UNITED STATES PATENT AND TRADEMARK OFFICE

APPLICATION NO.	FILING DATE	FIRST NAMED INVENTOR	ATTORNEY DOCKET NO.	CONFIRMATION NO.
10/520,935	08/23/2005	Michael Numminen	3670-55	4772
23117 7590 02/12/2007 NIXON & VANDERHYE, PC 901 NORTH GLEBE ROAD, 11TH FLOOR ARLINGTON, VA 22203			EXAMINER LIU, HARRY K	
			ART UNIT	PAPER NUMBER
			3662	
SHORTENED STATUTORY PERIOD OF RESPONSE		MAIL DATE	DELIVERY MODE	
3 MONTHS		02/12/2007	PAPER

DETAILED ACTION

FIG. 8

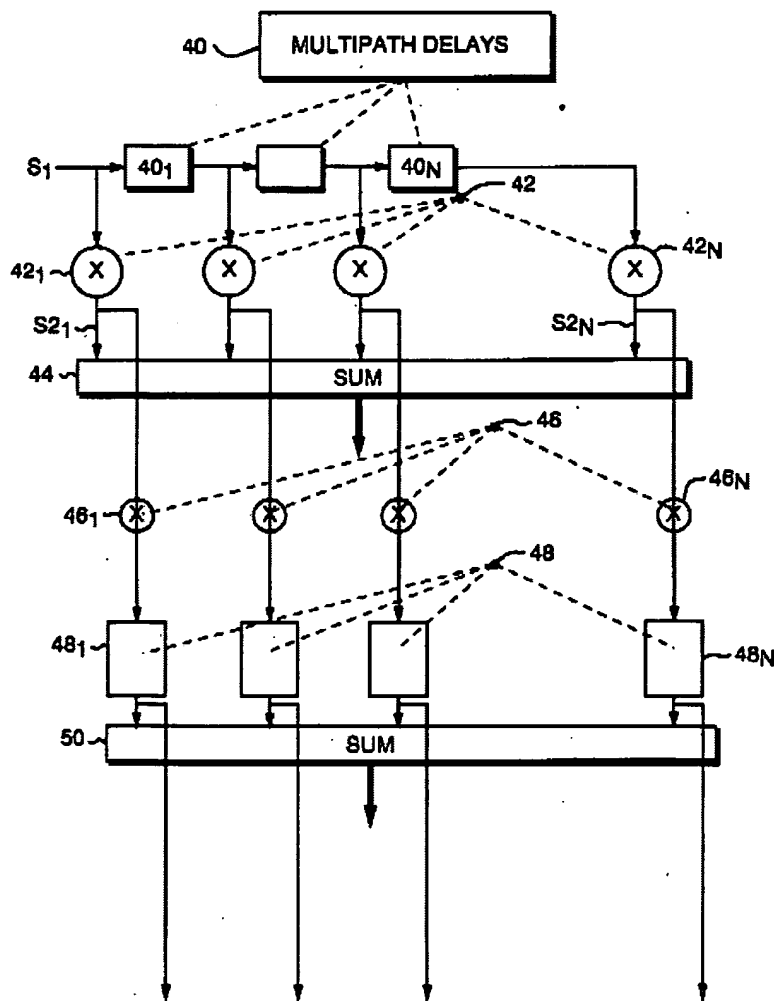
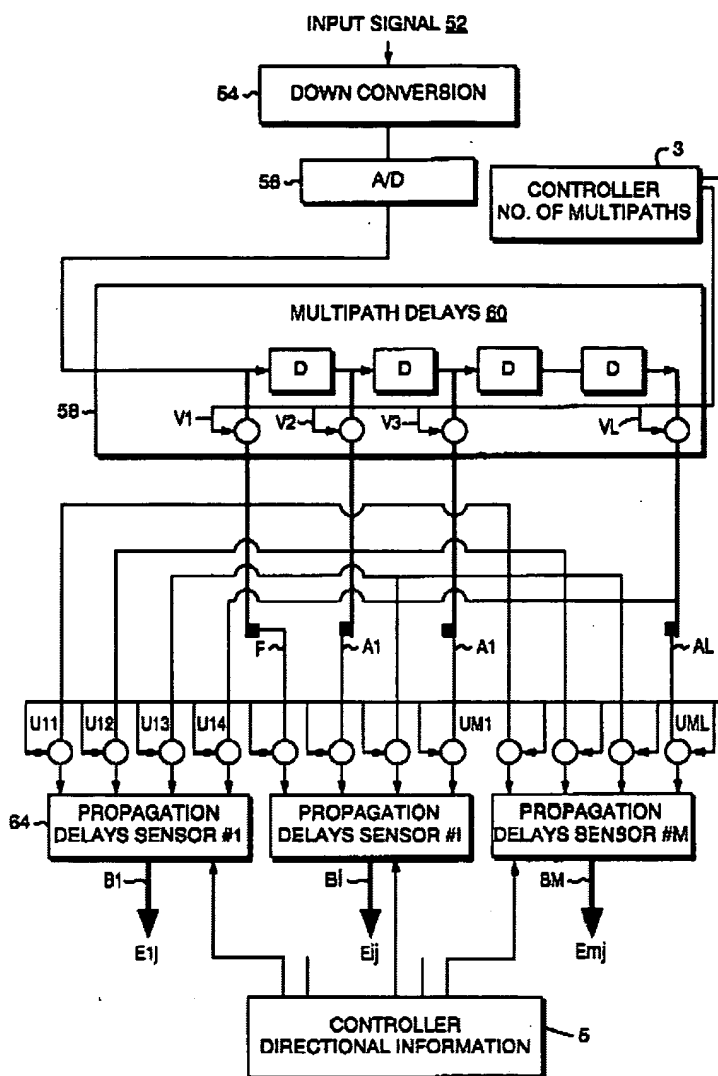
Considering **claims 3, 4, 9, 10**, Robbins discloses the direction in which the array has maximum response is said to be the beam pointing direction. Thus, this is the direction in which the array has maximum gain (**column 7, lines 15-25**). This is finding the **maximum point** for the corresponding **angle** on main lobe. The A/D converter for converting analog to digital is used (see **Fig. 9A below**) for **converting analog signals to digital signals**.
